Access Compliance Report Public Rights-of-Way (Pedestrian Signals)

Main Street: **ANTONIO_PKWY** Cross Street: **BENJAMIN_DR** Location: **SW**

ADA ID: **SGRK211020125816** Signal Type: **One Push Button-Non APS** Overall Compliance: **No** Severity Scores: **BTN 1: 35** **BTN 2: N/A** **No BTN: N/A**

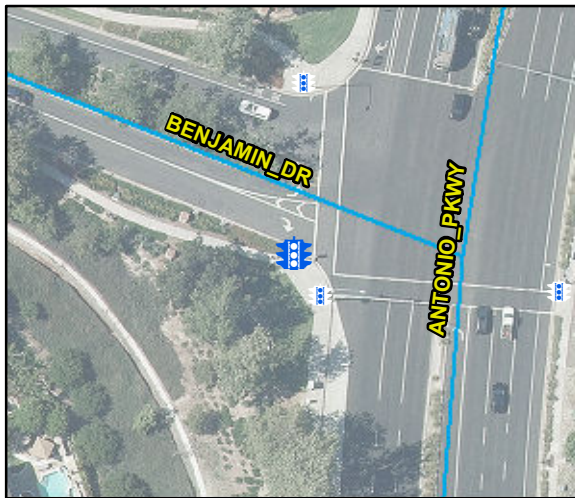
OC Std/PROW: **R404.2, R404.3, MUTCD 4e.08**

Possible Solutions: Replace Signal Push Button With APS Button. Remove and Replace Clear Space.
